Re: Rolling Sunrise Subdivision
File No. SUB 18840

TECHNICAL MEMORANDUM

Project:	**BGH, LLC, Rolling Sunrise Preliminary Plat**
To:	Alan Wallace – Attorney at Law, Williams Kastner
From:	Norman L. Olson, P.E. – N.L. Olson & Associates
Subject:	**Response to Browne & Wheeler 9-19-14 Letter**
cc:	Pat Ebert
Date:	September 22, 2014

RE: Rolling Sunrise Subdivision, SUB18840

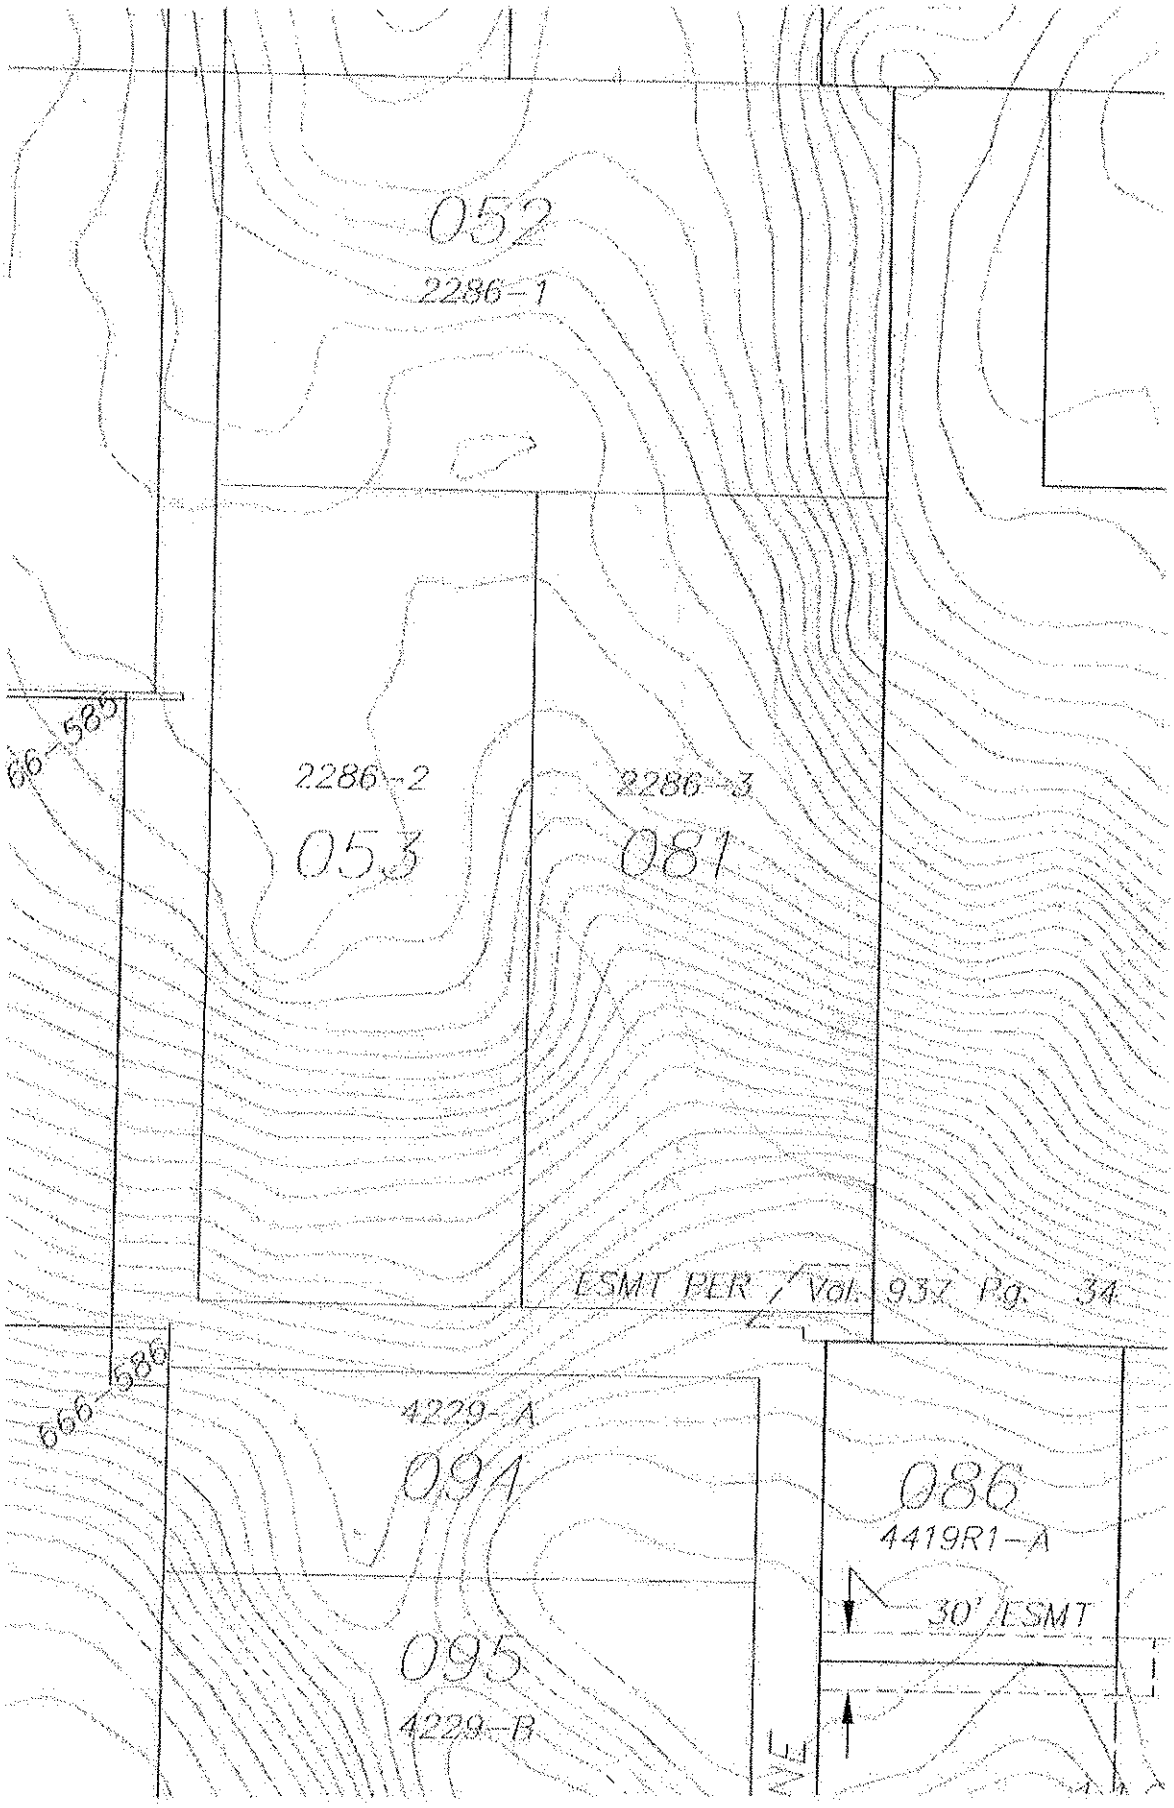
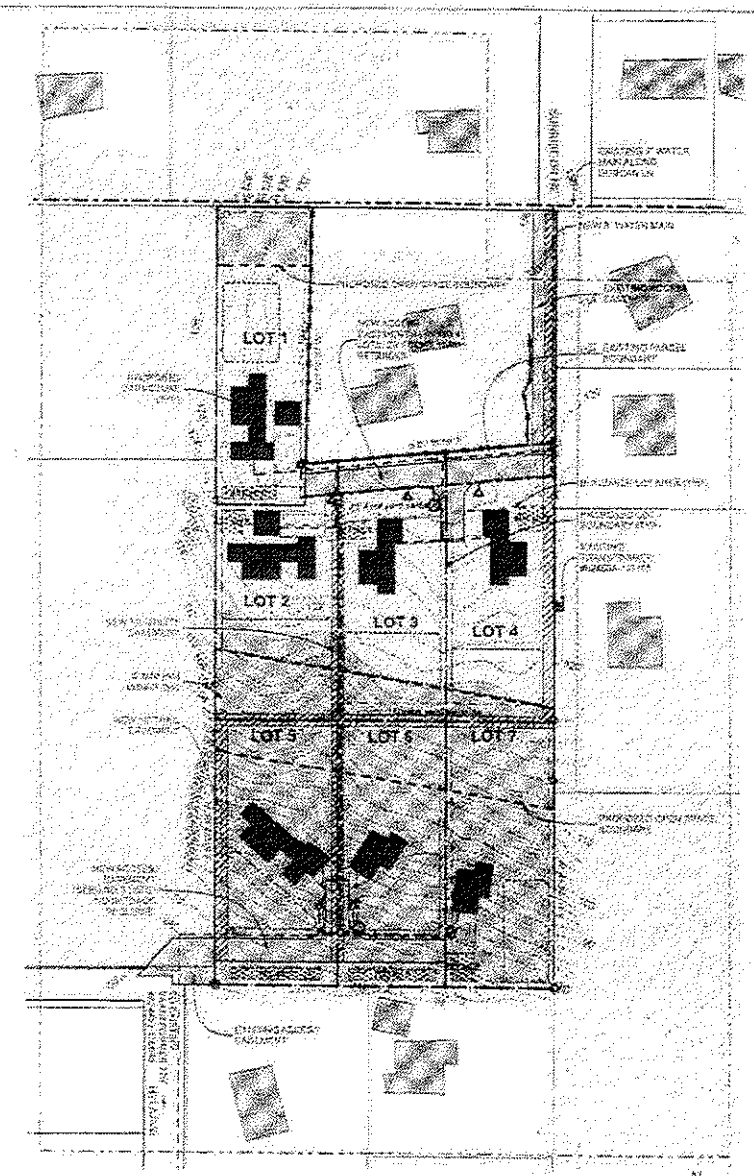
We just recently realized, upon reading the description of the BGH property more closely, and researching the original easement agreement for the easement created when my parents sold the parcel in the early 80's, that the easement granted to the BHG parcel on the lower west corner through the corner of our property is for 'ingress and egress' but NOT for utilities. I am consulting our lawyer on the implications, but we thought it was appropriate to bring this to your attention. We apologize if this information is being provided late in the process - we are new to the development/government hearing game.

Is this the kind of information that may impinge on this continuance process, or is this a matter that would be settled between us and BGH?

I've attached one of the BGH drawings, where the easement provisions for access on the lower west corner are clearly stated. The BGH drawing is the second page - please ignore the topographic drawing on the first page.
